RE: NHTSA Campaign No. 08V-126

**Re: NHTSA Safety Recall, Program- Campaign number 08V - 126 - Alternator B+ cable retention
Van Hool Coaches type C2045**

SERVICE BULLETIN

SB1210A

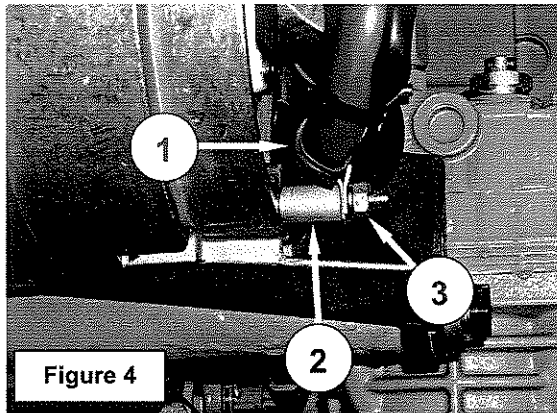
Undo the nut securing the terminal (1, Figure 3).
Undo the nut securing the D+ terminal (2, Figure 3).
Cut cable ties as required to allow re-routing of the B+ and D+ cables.

- 3) Referring to Figure 4, slip a P-clamp over the cable (1).
Install a spacer bushing over the lower most stud (2).
Install the P-clamp over the stud.
Install the lock washer and nut (3).
Adjust the cable routing for a stress-free installation.
Tighten the clamp nut to a torque of 80 in.lbf (8.6 Nm).

Tighten the B+ terminal nut to a torque of 80 to 115 in.lbf (9 to 13 Nm).
Tighten the D+ terminal nut to a torque of 21 to 28 in.lbf (2.4 to 3.2 Nm).
Re-secure the B+ and D+ cables with cable ties.

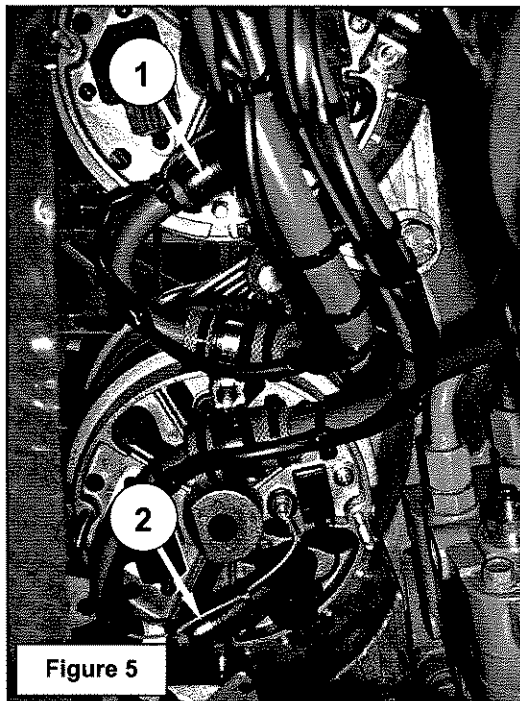
- 4) Repeat steps 1 and 2 for the lower most alternator.
- 5) Referring to Figure 5, check the cable routing to be compliant to the one shown. Adjust as necessary.
- 6) Turn on the battery disconnect switch.
